REV.	DESCRIPTION	DATE	DWG. BY
F.0	ADDED R4 RADIUS & GASKET	08 JULY 2024	JON. Y

DRAWING BY : JY	TITLE : 50 DIA.DISC WITH M10 THREAD			
		DATE : 08 JULY 2024				
TOLERANCE		CHECKED BY :	CUSTOMER : OPUS			
<input checked="" type="checkbox"/> 0 ± 0	DATE :					
<input checked="" type="checkbox"/> 0.X ± 0.20	APPROVED BY :	REVISION	MOLD No.	MATERIAL		
<input checked="" type="checkbox"/> 0.XX ±	DATE :	F.0	AG-020	316		
<input checked="" type="checkbox"/> 0.XXX ±	SCALE : N.T.S.	DWG. No. : AG50/6S-M10		REF. No. :		
<input checked="" type="checkbox"/> ANGULAR± 1°

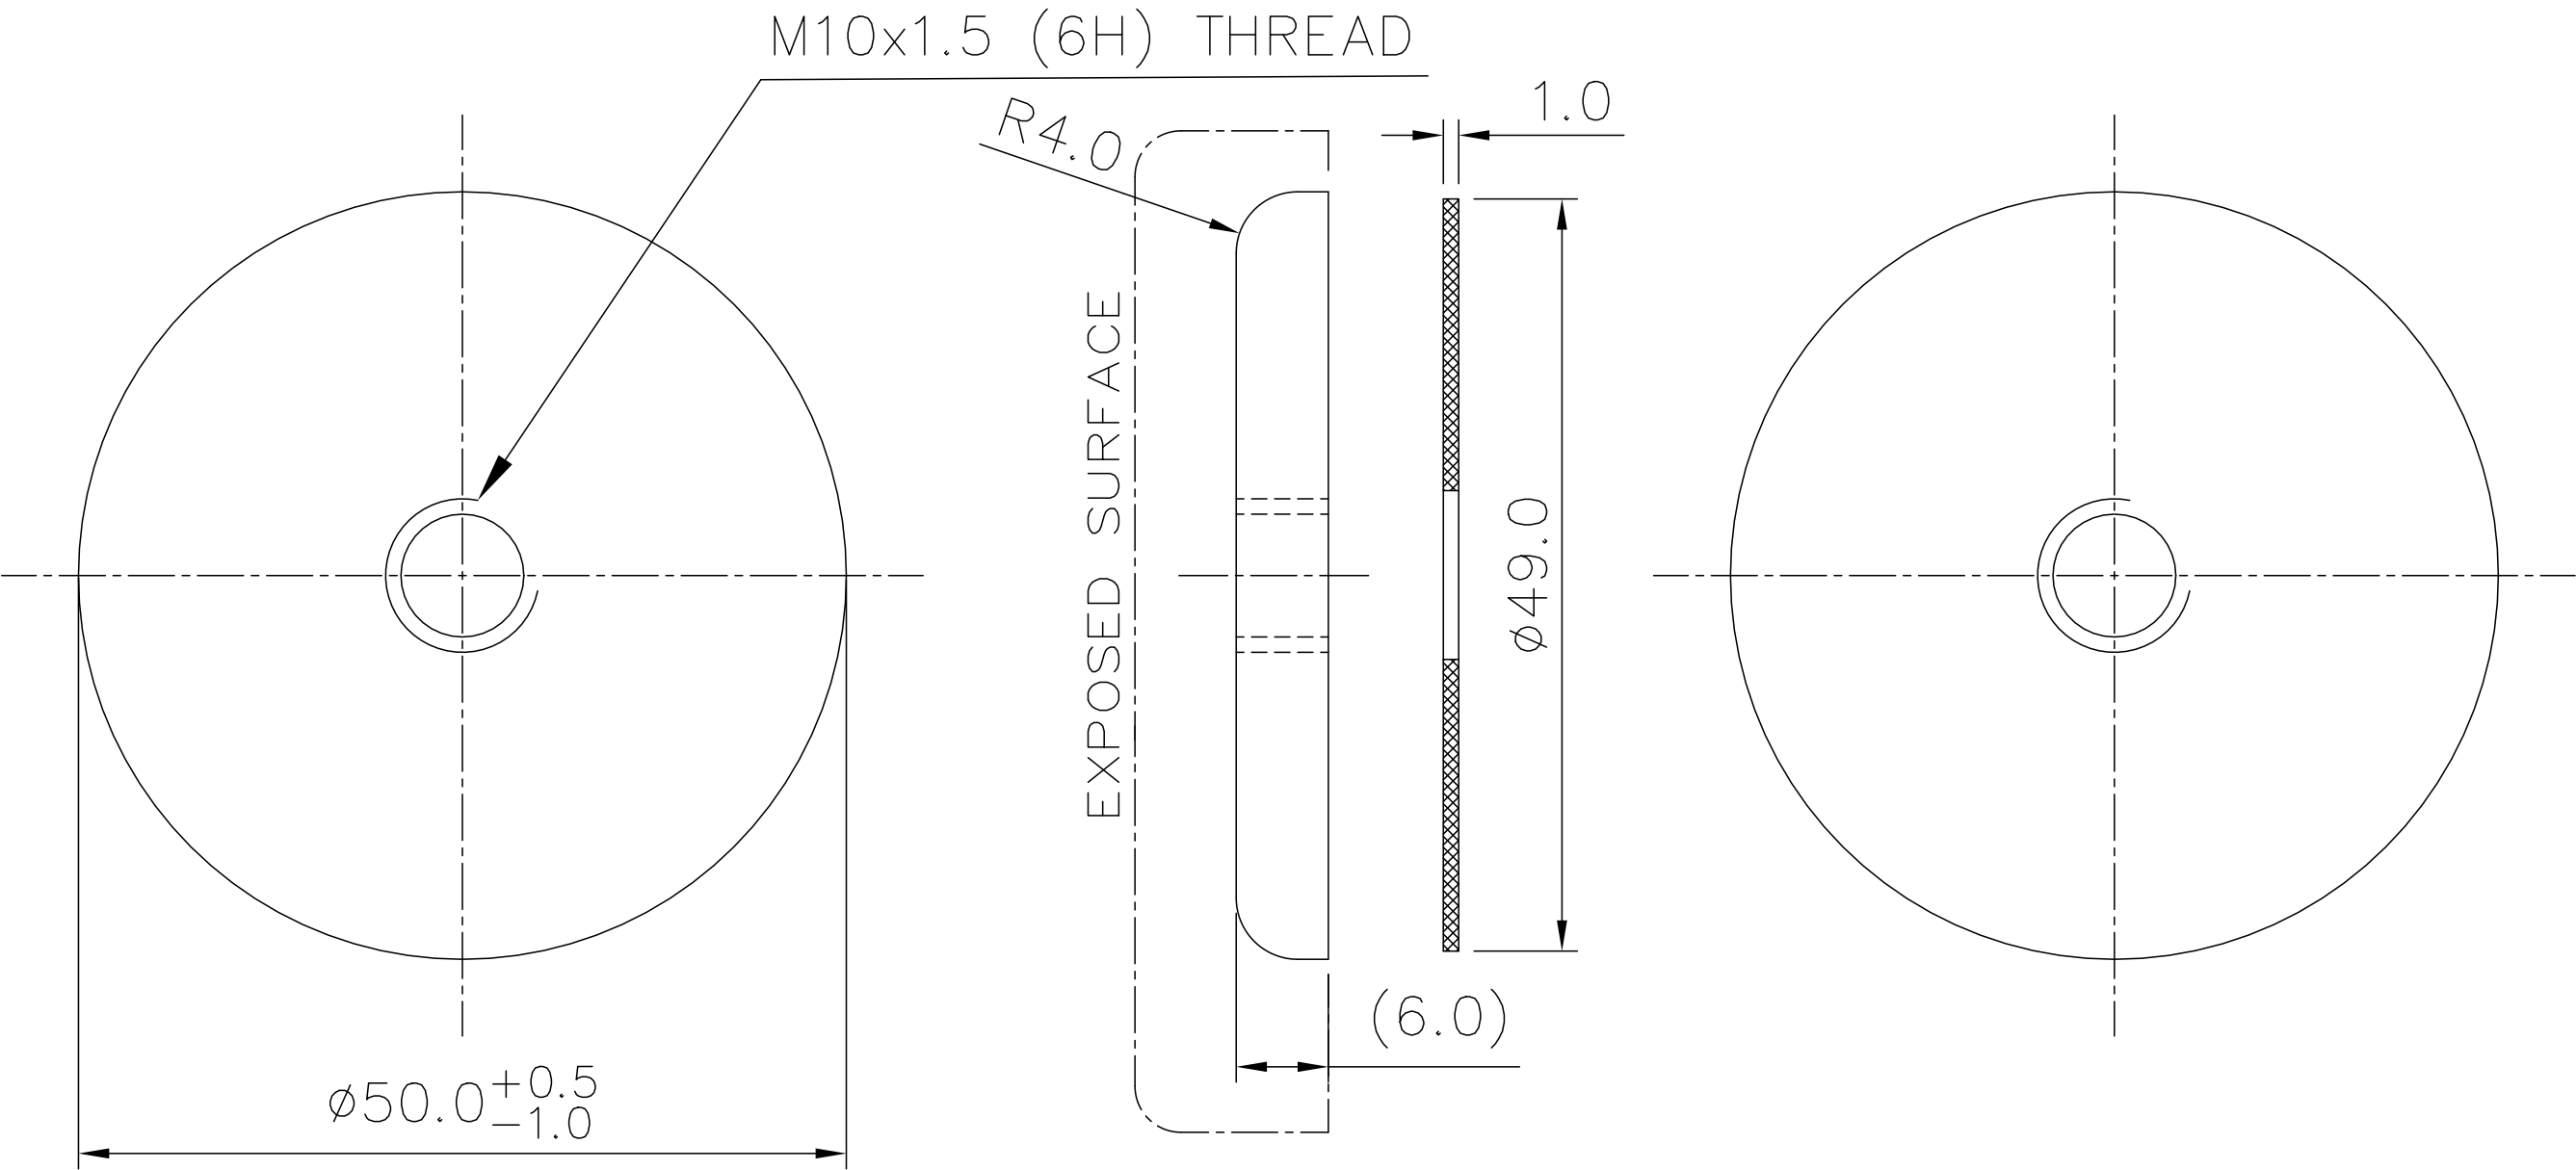
Note: D50X6THS-01 & AG50/6S-M10 same item. See which item code you would like to retain.

- 1. BREAK ALL SHARP EDGES
- 2. SATIN POLISH ON EXPOSED SURFACE
- 3. $\varnothing 49 \times \varnothing 11 \times 1\text{mm}$ U.V. STABILIZED NYLON 66 GASKET GLUED TO FTG
